MODIFICATION INSTRUCTION

Bulletin Nbr: 248-2245 Date:....juni 2000

Incorrect position, rear oxygen sensor cable US

Customer satisfaction campaign 118 41

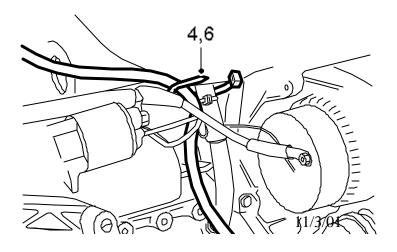
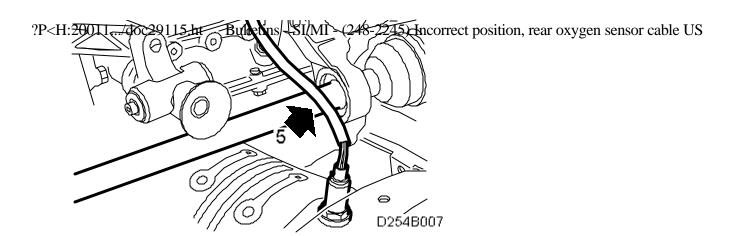
The rear oxygen sensor cable on certain cars may be lying too close to the intermediate shaft, which means that the cable sheath and insulation can be damaged. This is caused by the cable being poorly secured.

- 1. Check the oxygen sensor cable in the illustrated area
- 2. If only the outer sheath of the oxygen sensor cable is chafed, it will suffice to insulate the damaged area with insulating tape. Continue to step 4.
- 3. If the cable has been damaged down to the insulation then the oxygen sensor must be replaced. See WIS Engine Trionic T7 OBD2 Adjustment/replacement Rear oxygen sensor. Do not forget to secure the cable with the cable tie as described in steps 5-7.
- 4. Cut off the cable tie securing the rear oxygen sensor cable to the oil filler pipe.
- 5. Run the cable so it is not resting against the intermediate shaft. It must not be taut either
- 6. Secure the cable to the oil filler pipe with a new cable tie.
- 7. Cut off the loose end of the cable tie.
